FIRE SAFETY INSPECTION REPORT

LIZ FASHION INDUSTRY LTD.

ACCORD
on Fire and Building Safety in Bangladesh

April 6, 2014

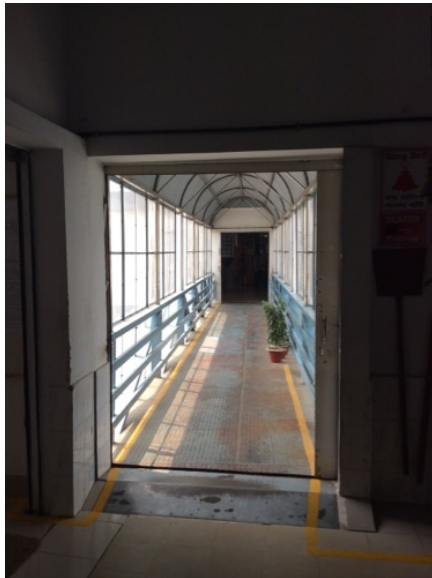
No.	Category	Finding	Recommendation	Remediation Timeframe
F-1	Fire Rated Construction	Areas used for combustible storage are not separated by fire-rated construction. Locations: Multiple floors in factory areas.	Provide dedicated storage rooms separated by minimum 1-hr fire-rated construction. Where separate storage rooms are not feasible, provide defined storage areas and limit the storage arrangement as follows: - Maximum height of 2.4m and maximum area of 23m² - If sprinkler protected: maximum height of 3.66m and maximum area of 93m² Separate areas of unenclosed combustible storage by a minimum clear distance of 3m.	Within 3 months
